PROCEDURE CHANGE NOTICE (PCN)

PCN No. 01

- a. Number 2IM-5.02-CND Revision 2
 b. Title Conduit and Conduit Support Design

TU ELECTRIC
COMANCHE PEAK ENGINEERING
UNIT 2

ATTACHMENT 8.B (CONT)

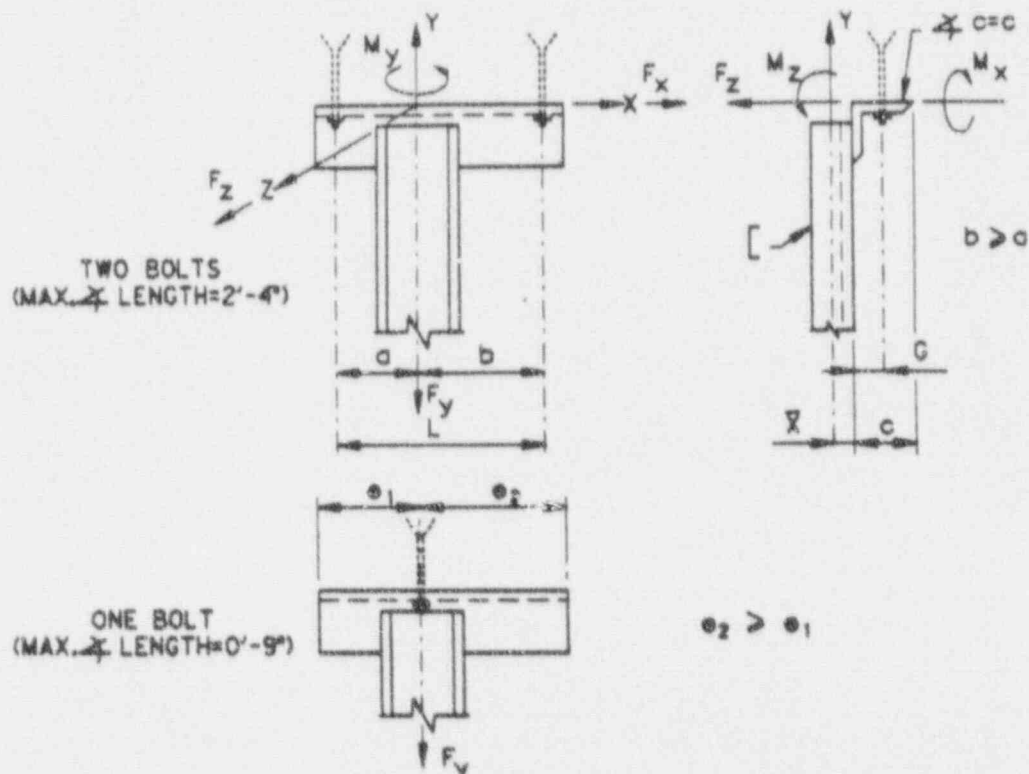
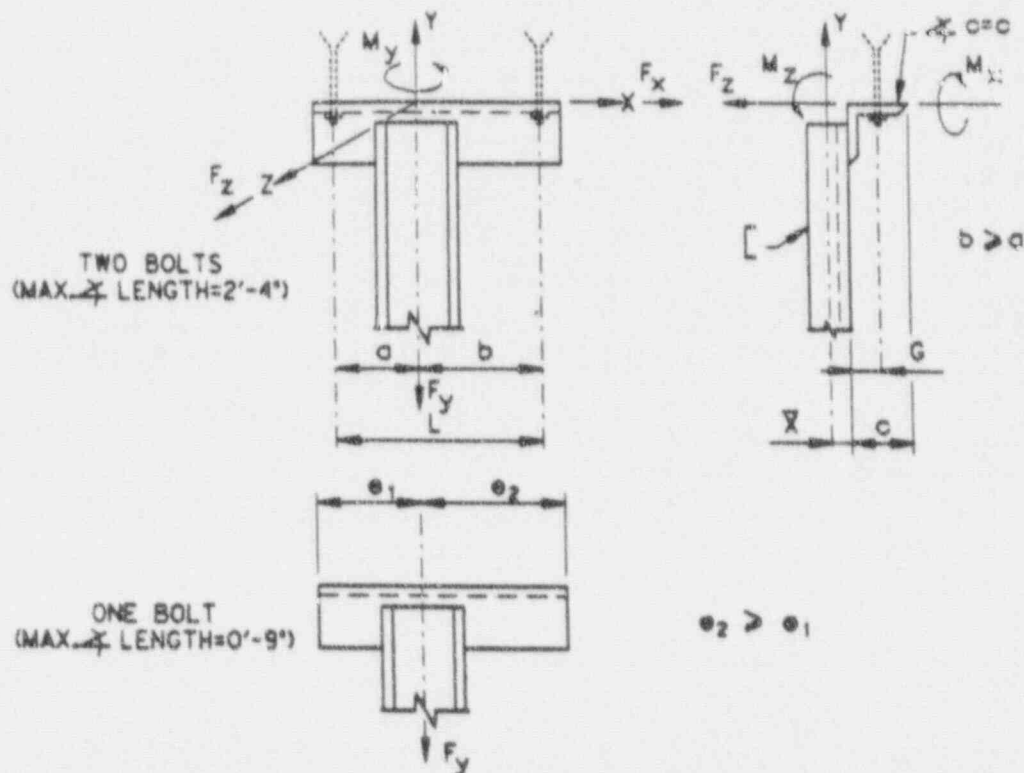
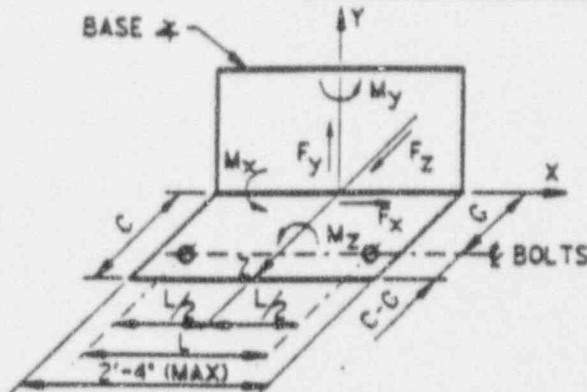
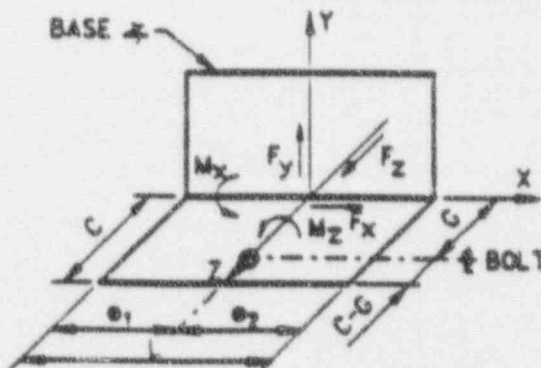
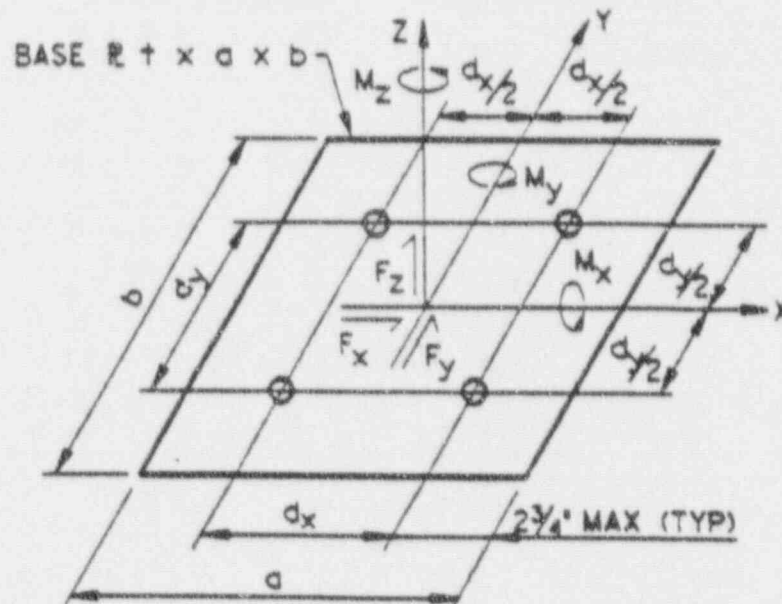
1. Clarifications and corrections of typographical errors.
2. Correction of Prying Factors in Attachment 8.B.
3. Use of maximum allowables for air drops and flexible conduit lengths in lieu of actual lengths.

1. No justification required.
2. No backfit required per calculation 0218-CO-0418, Revision 0.
3. Backfit required. Review of issued designs required to determine impact.
